Attachment D

RE: 25475 Hatton Proposed ADU and Redwoods

Subject: ADU Tree Impact Assessment for 25745 Hatton Road, Carmel

Re: PLN240104 – 25745 Hatton Rd., Carmel (Kitayama Nagafuji)
Our File: 60107.70158

S. sempervirens with 3 test sites to determine if any roots are impacted by development.

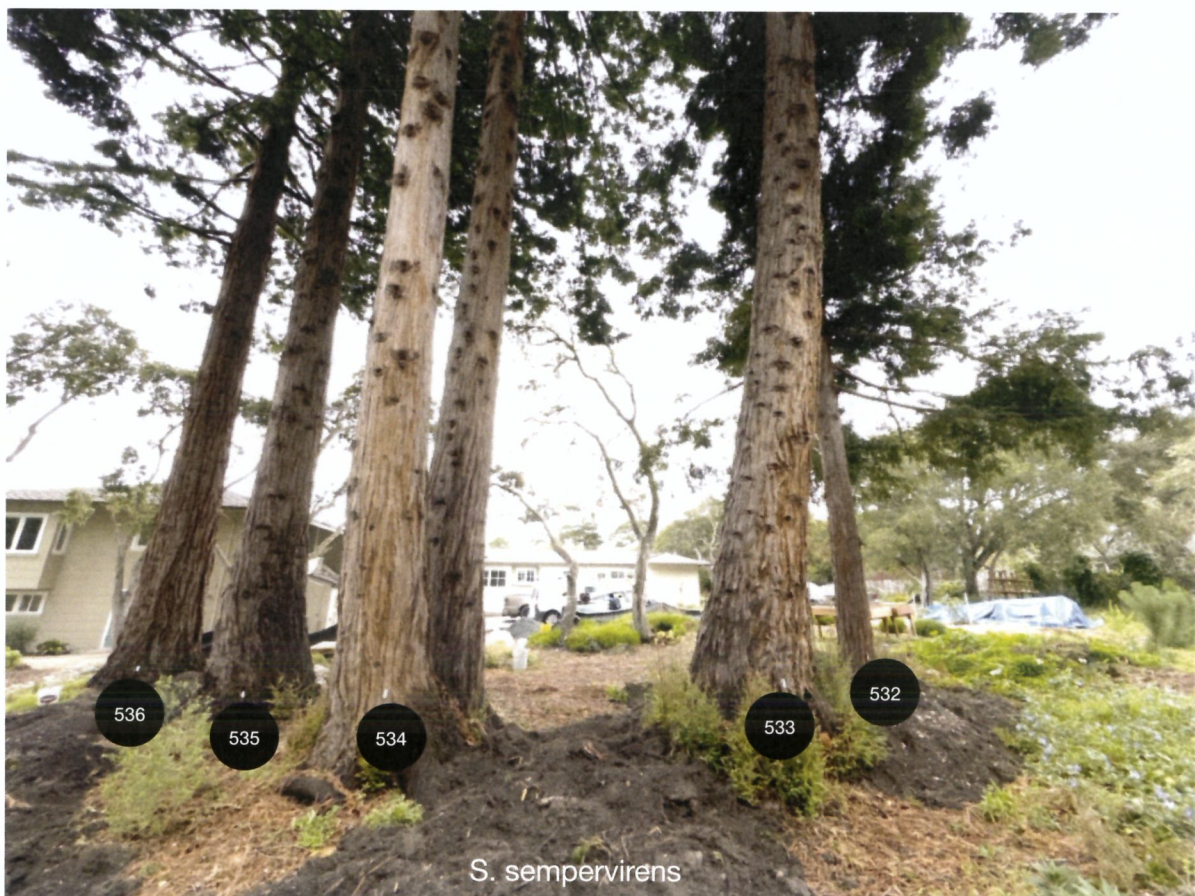
Test site 1 has minimal $\leq 1"$ diameter non-woody roots and no primary roots. Impacts are none.

Test site 2 has minimal $\leq 1"$ diameter non-woody roots and no primary roots. Impacts are none.

Test site 3 has minimal $\leq 1"$ diameter non-woody roots and no primary roots. Impacts are none.

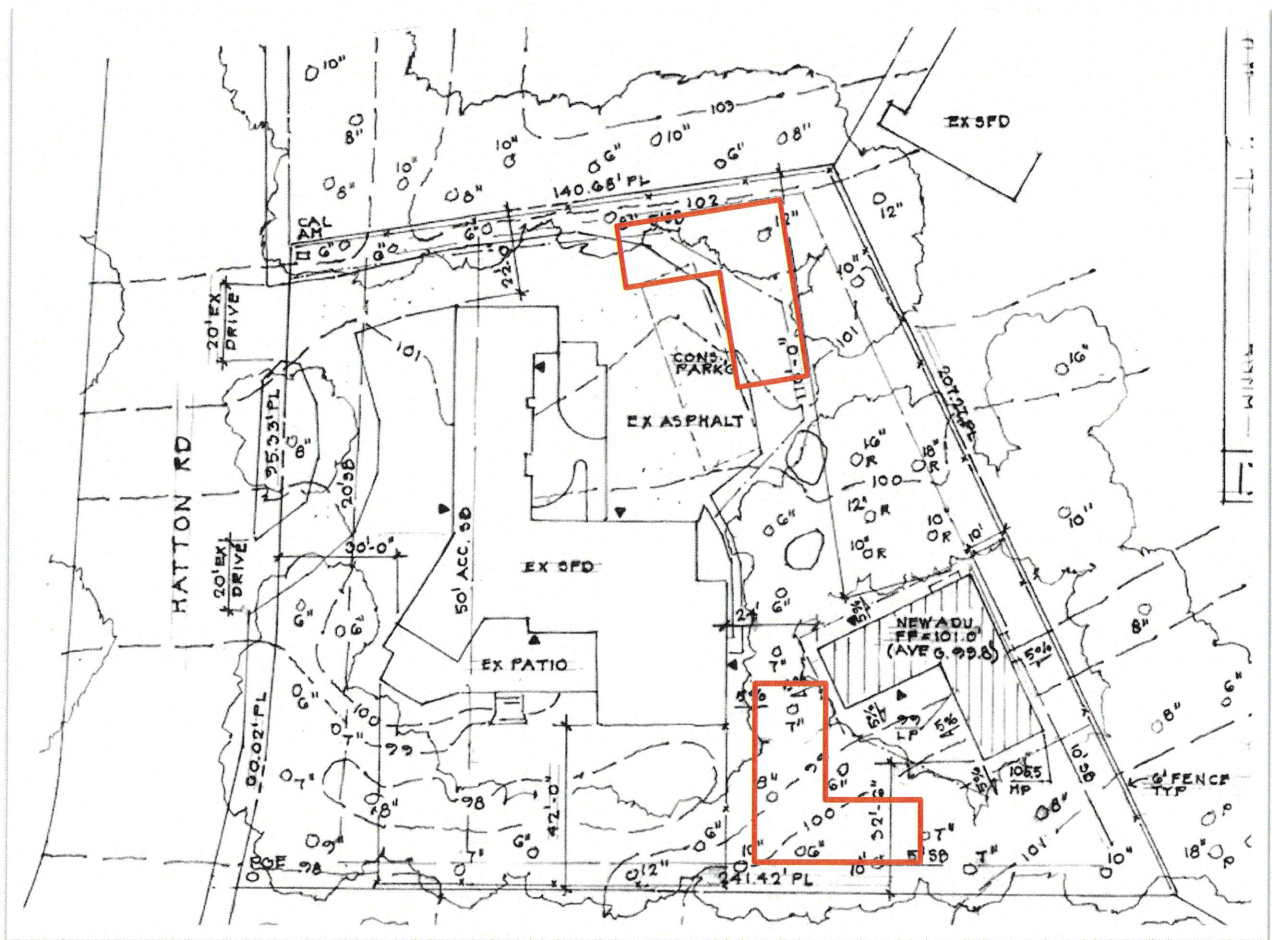
Moreover, Mr. Bradford’s Report confirms the Project will be detrimental to the health and safety of the Russes:

“Installation of a concrete foundation which outlines the footprint of the ADU will require severance of the roots of those trees in that area of the grove rooting bed, and will prohibit or greatly inhibit future tree rooting in the footprint area. This can effect the vertical stability of those trees as they grow in height.”

The Russ' daughter's bedroom is the closest room to the Kitayama Property. Should the Project cause one of the Redwood trees to fall (especially in a storm), their daughter would be in grave danger.
